**Subject: Application for Modification to Section 404 Nationwide Permits 23, 33, and 13, Section 401 Water Quality Certification, and Neuse Riparian Buffer Authorization** for the replacement of Bridge No. 29 over Clarks Creek on SR 1007 (Poole Road), Wake County. Federal Aid Project Number BRSTP-1007(8), WBS No. 33637.1.1, State Project No. 8.2409201, Division 5, T.I.P No. B-4300.

References: Section 404 Nationwide (NW) Permit Numbers 23, 33, and 13, issued June 6, 2008, USACE Action ID 2004-20705  
Section 401 General Water Quality Certification and Neuse Riparian Buffer Authorization, issued February 22, 2008, NCDENR-DWQ Water Quality Certification Project No. 20080313.

NCDOT  
DIVISION OF HIGHWAYS  
WAKE COUNTY  
PROJECT: B-4300 (BRIDGE #29)  
BRIDGE NO. 29 OVER  
CLARKS CREEK  
ON SR 1007  
(POOLE ROAD)

Permit Drawing  
Sheet 8 of 10

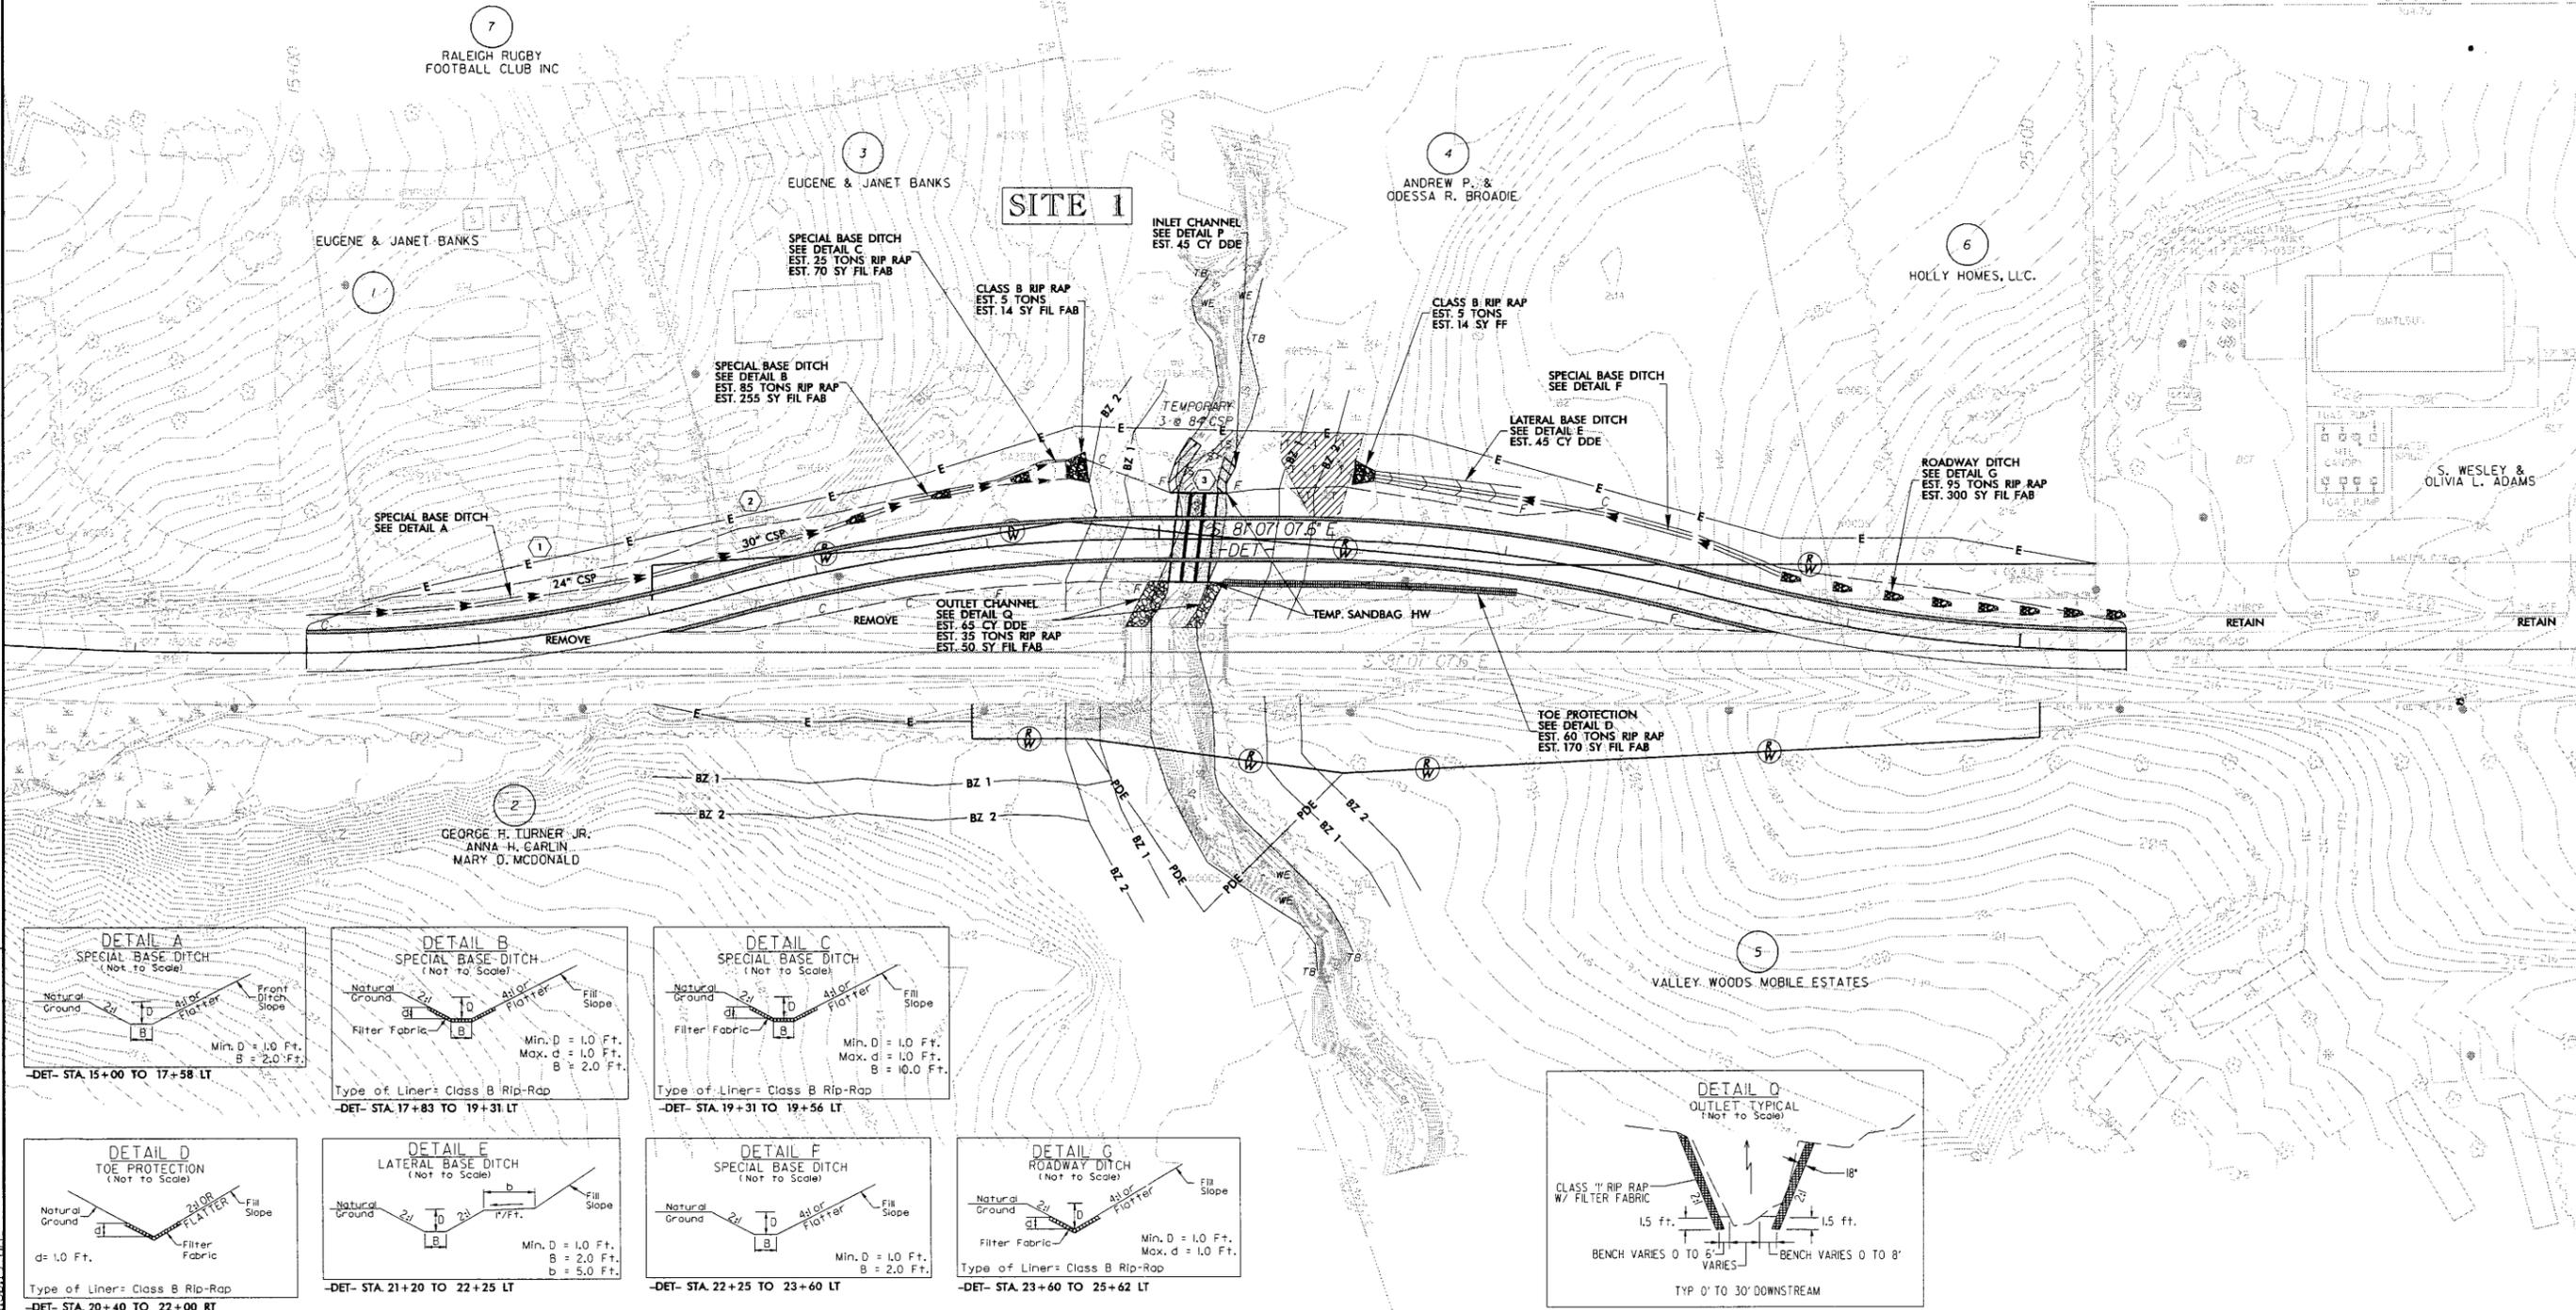
Construction of this project will involve the installation of 3 @ 84 inch corrugated steel pipes to convey Clark's Creek at Station 20+10 under the temporary on-site detour during construction of the project. This has been previously considered a temporary impact to Clark's Creek in the original permit. Installation of the three structures will require significant excavation in Clark's Creek and the adjacent bank and floodplain. An evaluation of the stream in this area indicates a fairly incised, unstable stream that exhibits high flow during rain events. The NCDOT Division 5 personnel have reviewed this area and have determined that the banks of Clark's Creek cannot be adequately stabilized with traditional non-hardening methods such as coir fiber matting after removal of the pipe structures. The NCDOT has determined to permanently install Class I rip-rap on the streambanks within the limits of the temporary pipe structures for bank stabilization. This results in changing the 55 linear feet of temporary stream impact from the original permit to permanent impact. An additional 16 feet of temporary impact in Clark's Creek from the inlet channel of the temporary pipes upstream to the easement line has also been calculated since the original permit (Permit Modification Summary Table for Site 1).

The unnamed tributary to Clark's Creek flows parallel to the roadway from Station 17+00 to 20+00 Rt. The original design indicated that the UT to Clark's Creek would reach its conveyance to Clark's Creek downstream of the culvert wing wall. The NCDOT Division 5 Survey party staked the limits of the culvert and wing wall and determined that there is a direct conflict with the wing wall and the UT to Clark's Creek. The NCDOT Division 5 office has determined to relocate the lower end of the unnamed tributary to Clark's Creek to avoid this conflict. This results in a change from 95 linear feet of temporary impacts in the original permit to 51 linear feet of permanent stream impact and 44 linear feet of temporary stream impact (Permit Modification Summary Table for Site 2).

PRELIMINARY PLANS  
DO NOT USE FOR CONSTRUCTION  
Permit Drawing  
Sheet 9 of 10  
FOR -L- PROFILE SEE SHEET 5

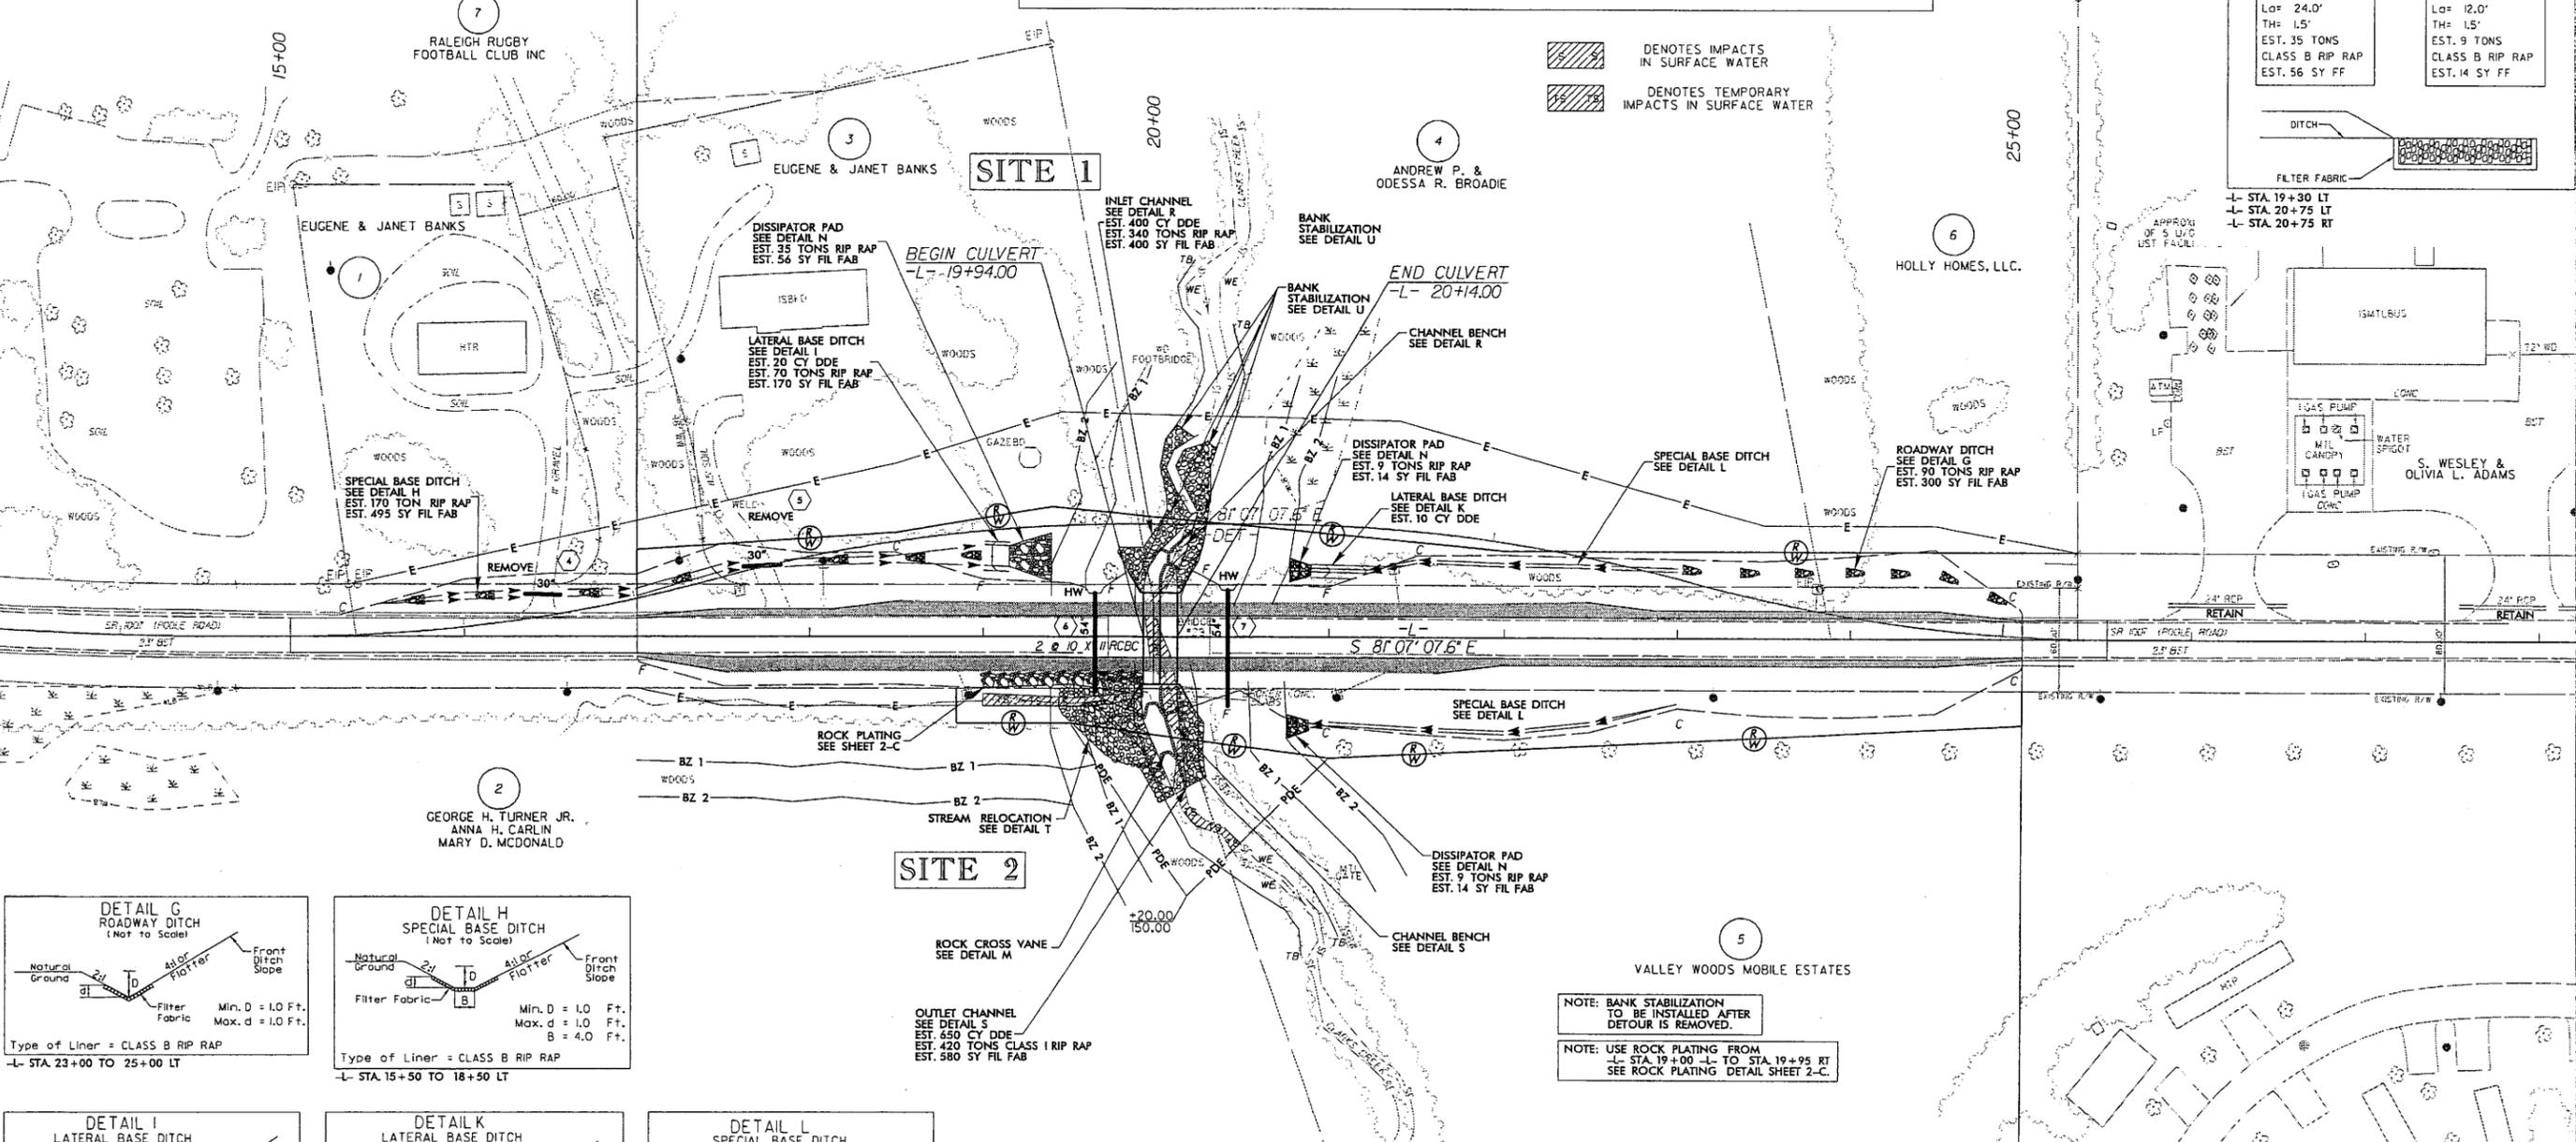
The NCDOT has also determined that an additional 22 linear feet (permanent impact) of rip-rap along the stream channel in Clark's Creek was necessary for bank stabilization associated with the culvert installation. This reach was previously considered as temporary impact in the original permit. This results in decreasing the temporary stream impact of Clark's Creek from 70 linear feet to 48 linear feet. A total of 170 linear feet (148 linear feet in original permit) of permanent stream impact to Clark's Creek is associated with the culvert installation; 63 feet due to the box culvert installation and 107 feet (85 feet in original permit) of channel improvements and rip-rapping along the stream banks for bank stabilization (Permit Modification Summary Table for Site 1).
